UNITED STATES ENVIRONMENTAL PROTECTION AGENCY
REGION IX
75 Hawthorne Street
San Francisco, CA 94105

MEMORANDUM

RE: Duck Valley Emergency Order Work Plan

See Map #2 for EPA recommended sampling locations;

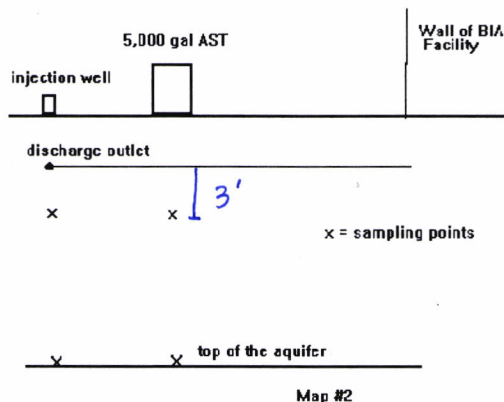
A more detailed description of 4 sample points of the area surrounding the drain system must be given, either a written description or a map with the sample points clearly marked is acceptable.

Point A (refer to part d of BIA Work Plan--only one sample is necessary at this point. If BIA chooses to do only one sample (Work Plan has 2 samples at this point), the one sample must be taken 1' below the connection of the south sump to the drain line. The sample should not be taken 'one to two feet below the concrete slab';

Point B (refer to part e of BIA Work Plan)--one sample below the vertical pipe is acceptable;

Point C (Refer to part g of BIA Work Plan)--four samples are to be taken in the area around the discharge outlet.

Points #1 and #2 (refer to part f of BIA Work Plan)--The BIA Work Plan includes four samples along the drain line of the drain system, EPA suggests at Point #1, two samples be taken. One 3' below the elbow of the drain line and the second at the surface of the water table. At Point #2, two samples should be taken. One sample 3" below the end of the vertical pipe and a second sample at the top of the water table.
